DOCUMENT 00 9010
ADDENDUM NUMBER 01

DATE: **October 6,2022**
PROJECT: SE Branch Library Parking Lot Replacement
PROJECT NUMBER: PJ000106
OWNER: City of Arlington
ARCHITECT: Simon Engineering & Consulting, Inc.
 15443 Knox Trail Drive, Suite 140
 Dallas, TX
 Ph: (214) 884-2056
TO: Prospective Bidders

**CITY OF ARLINGTON
SE BRANCH LIBRARY PARKING LOT REPLACEMENT
QUANTITY SUMMARY**

CITY OF ARLINGTON, TEXAS
ARLINGTON PUBLIC LIBRARY SOUTHEAST BRANCH
PAVING PLAN
900 SE GREEN OAKS BLVD, ARLINGTON, TX 76018

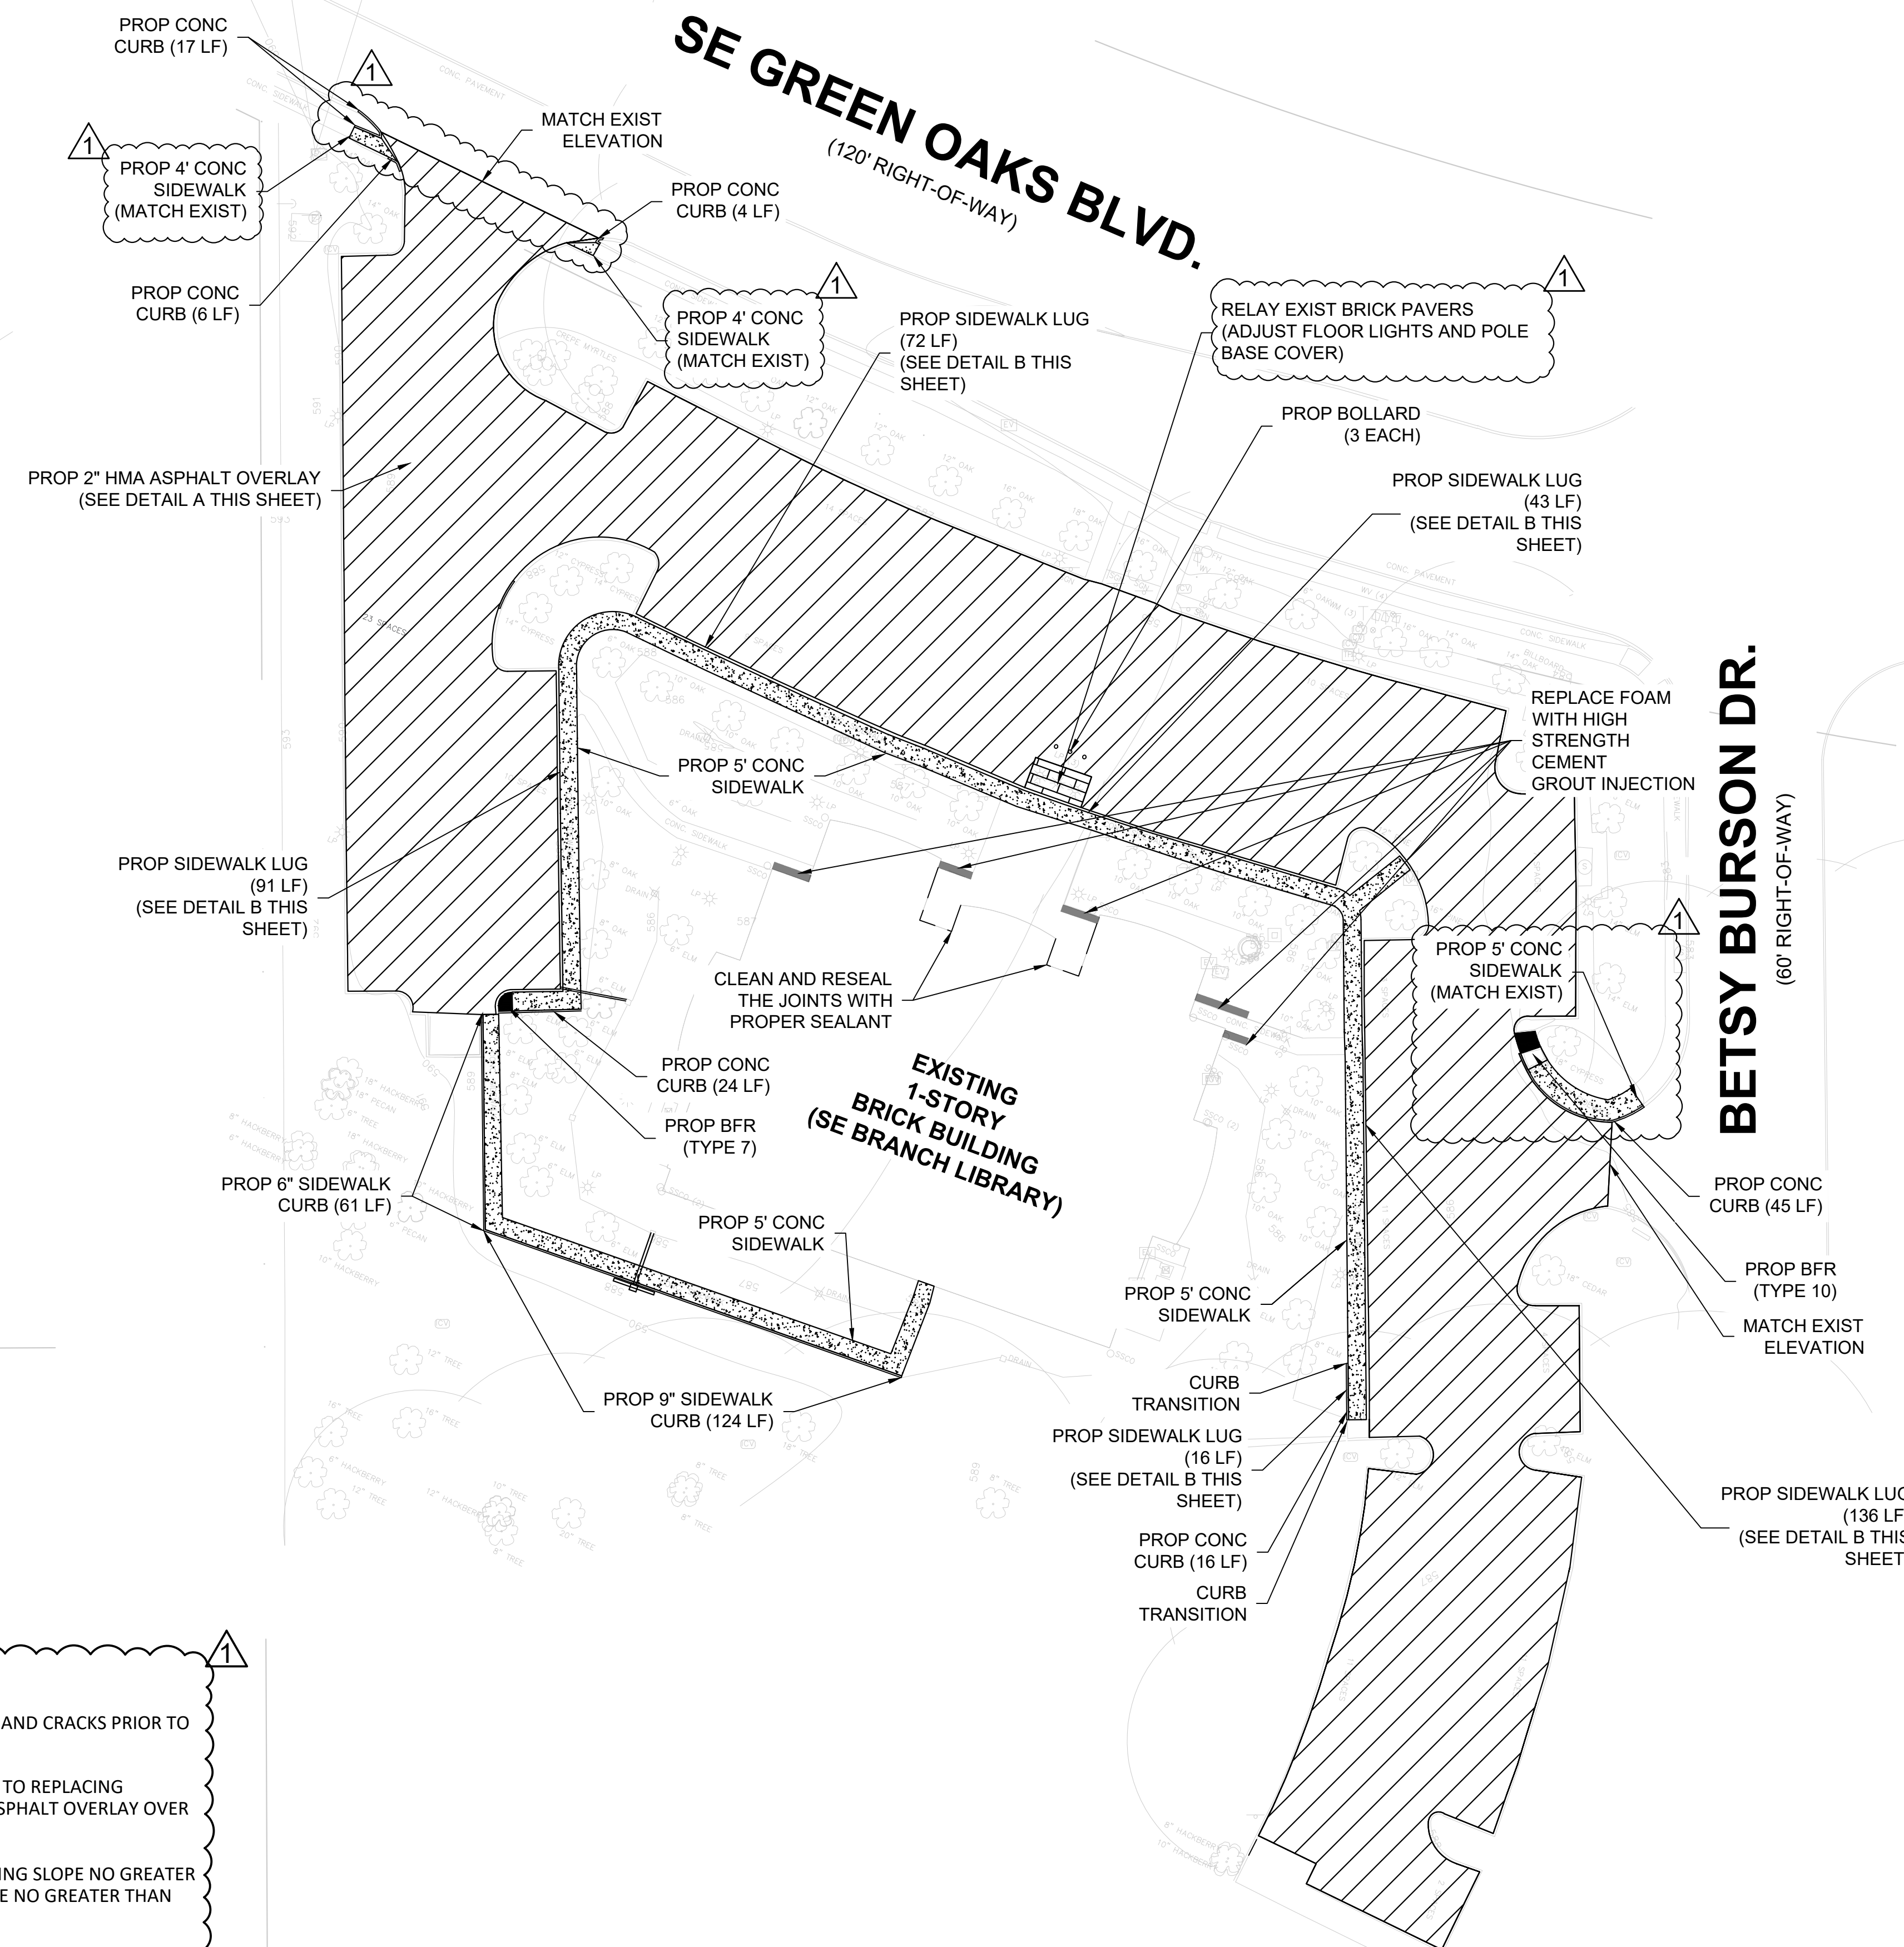
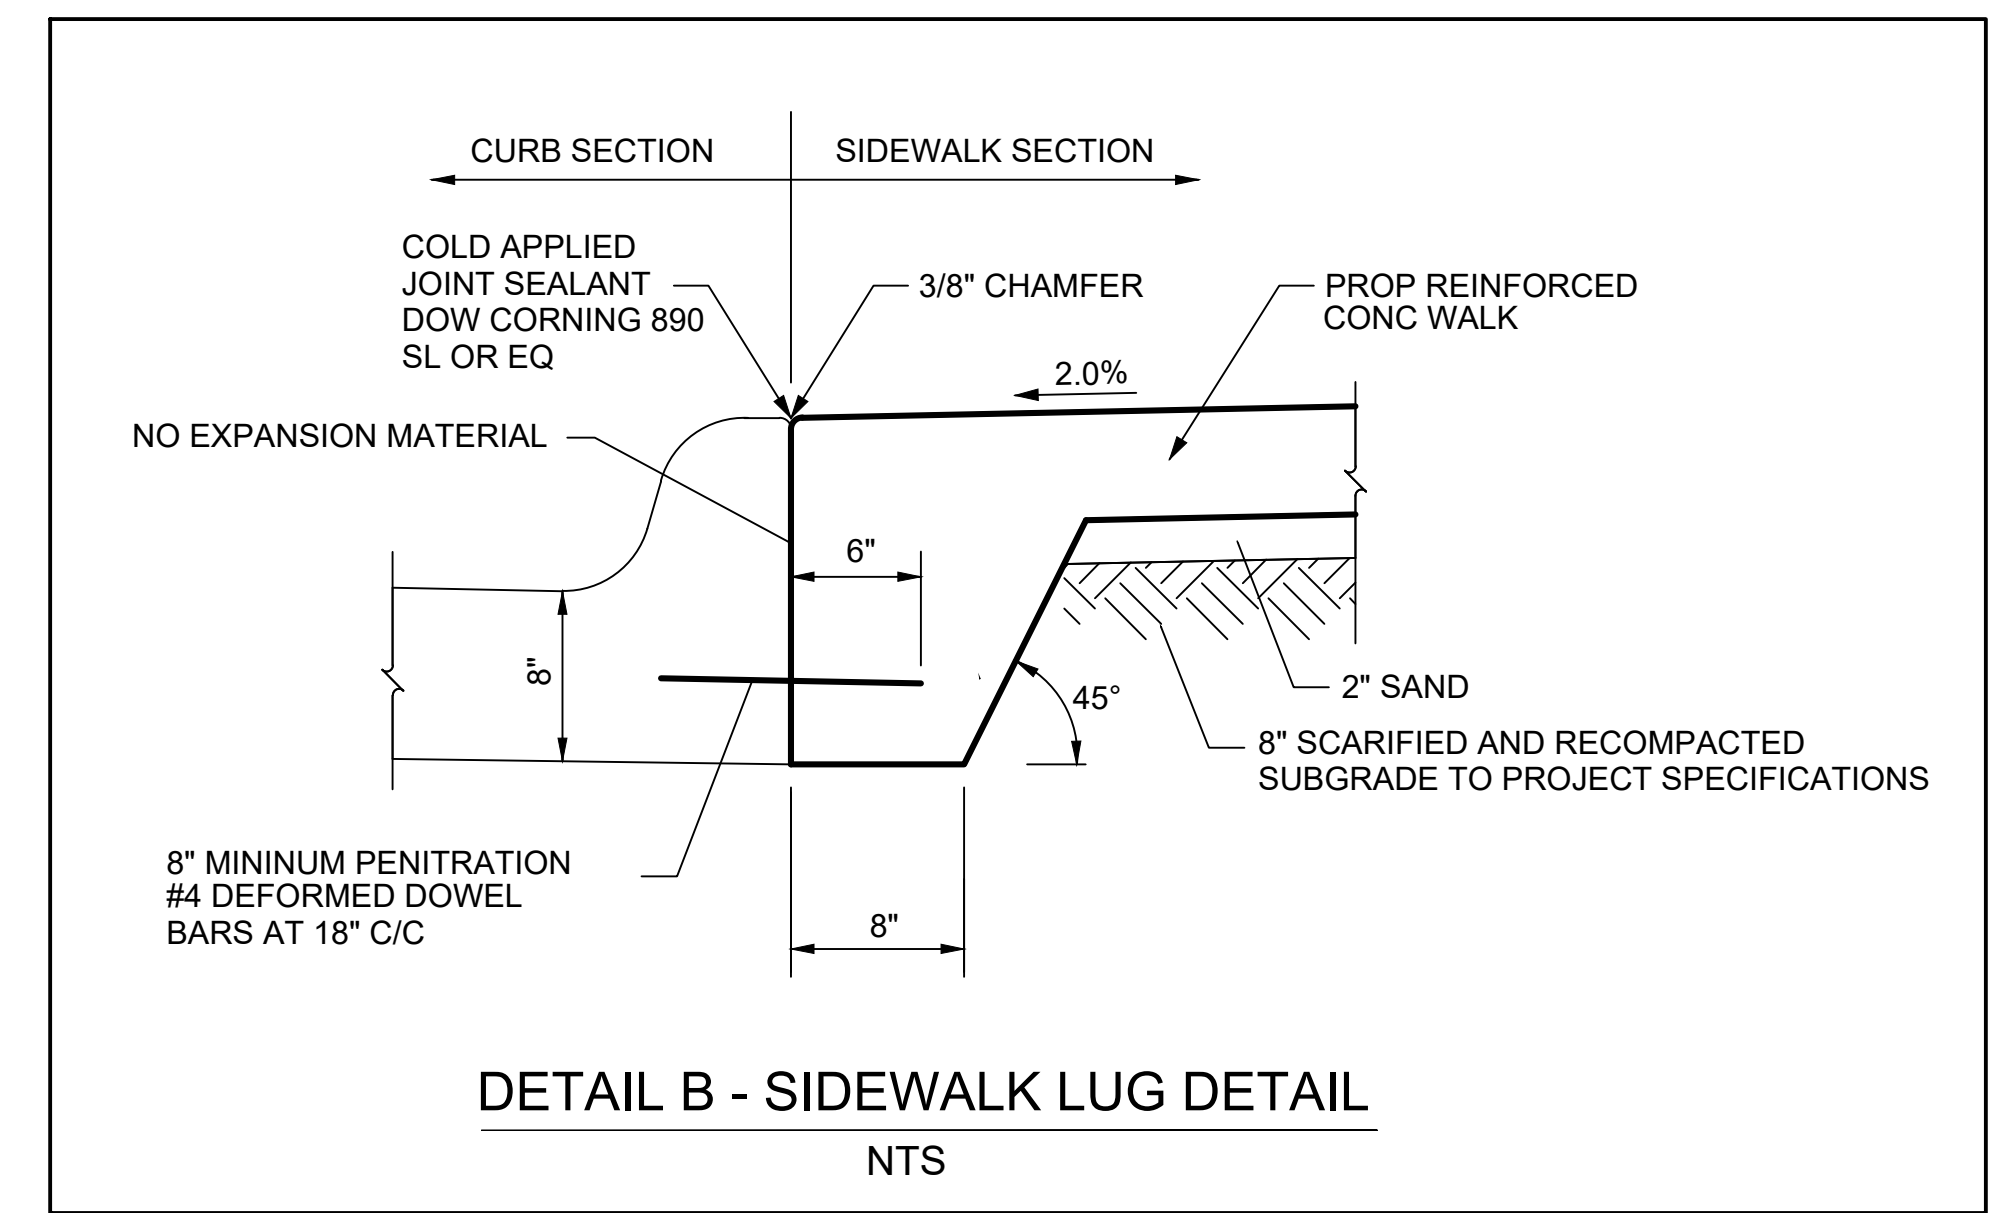
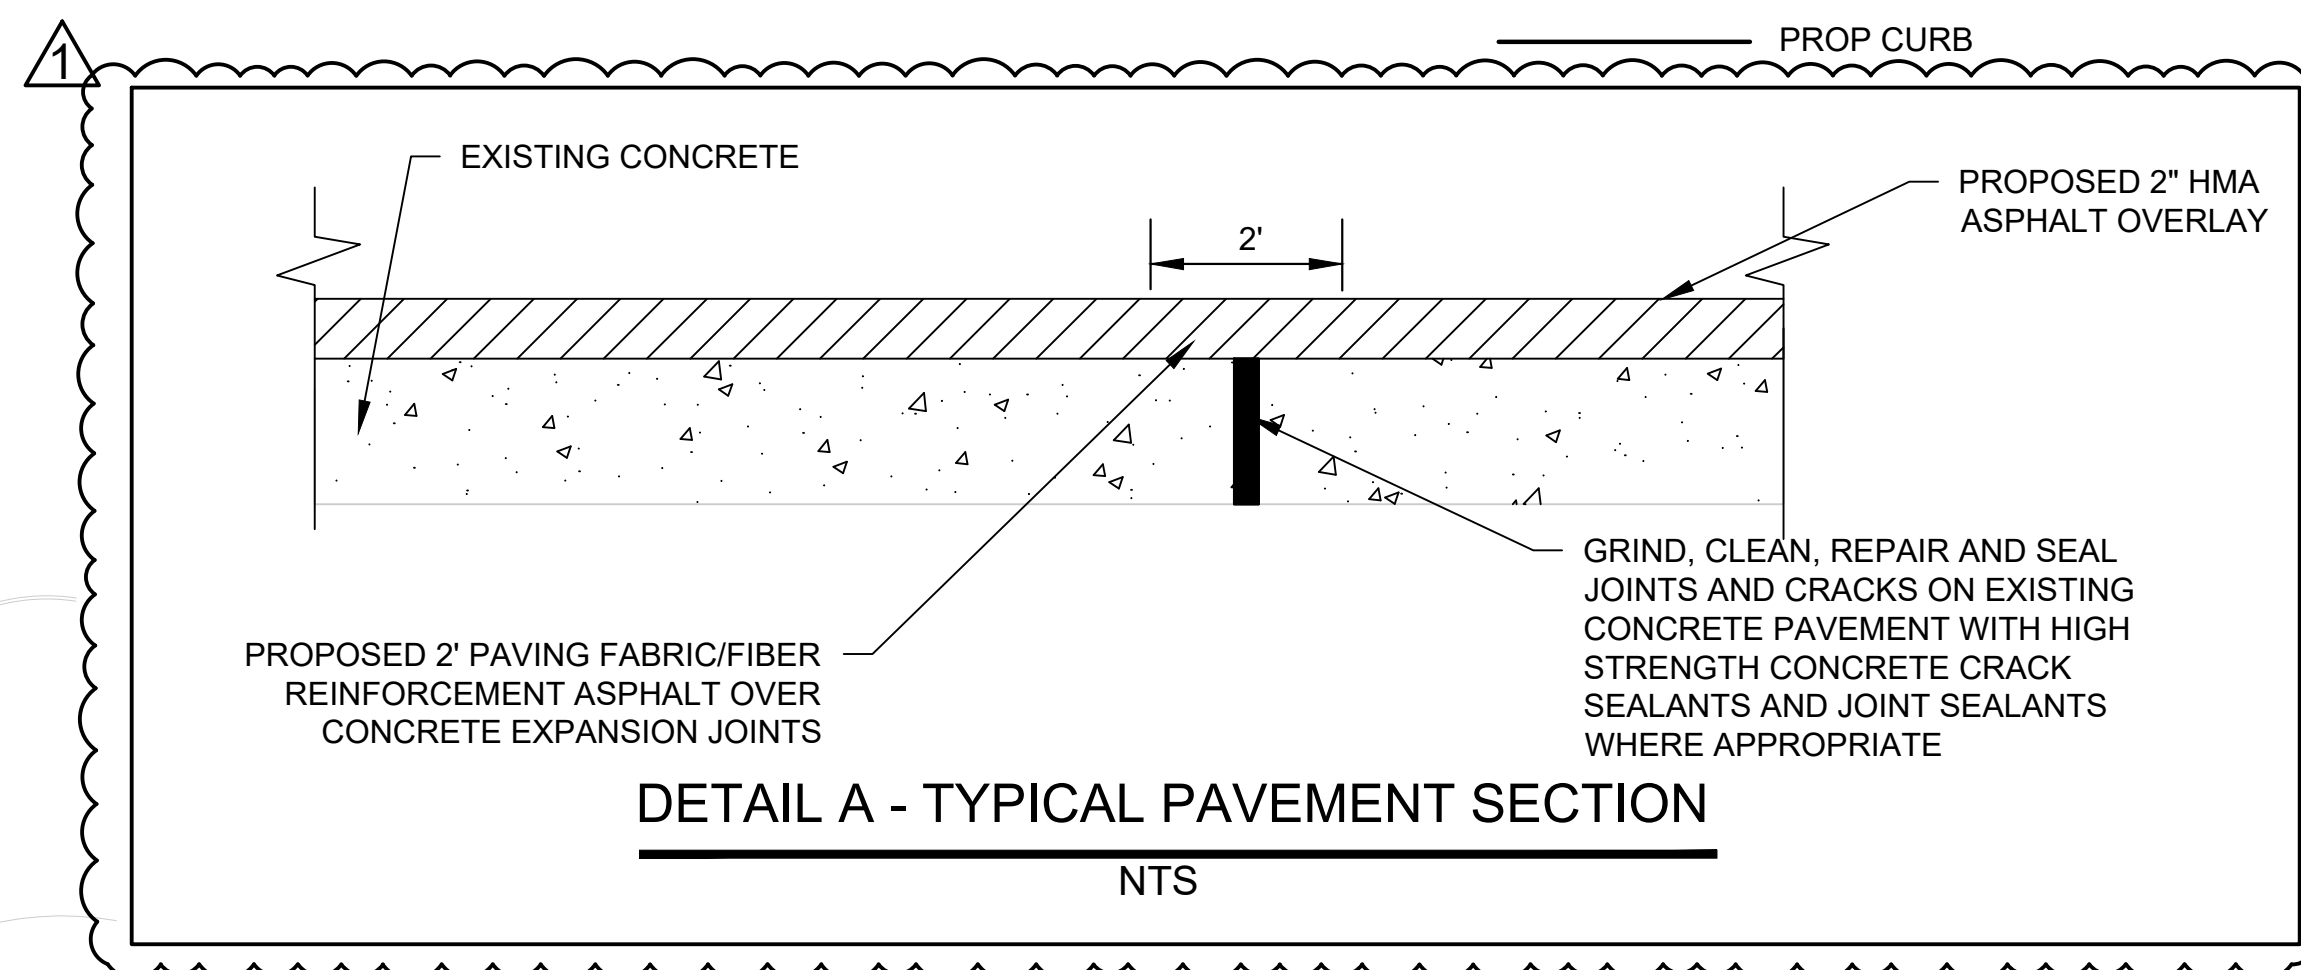
| No. | Date | Revisions |
|-----|------------|--------------------------------|
| 1 | 10/05/2022 | PAVING PLAN AND DETAIL REVISED |
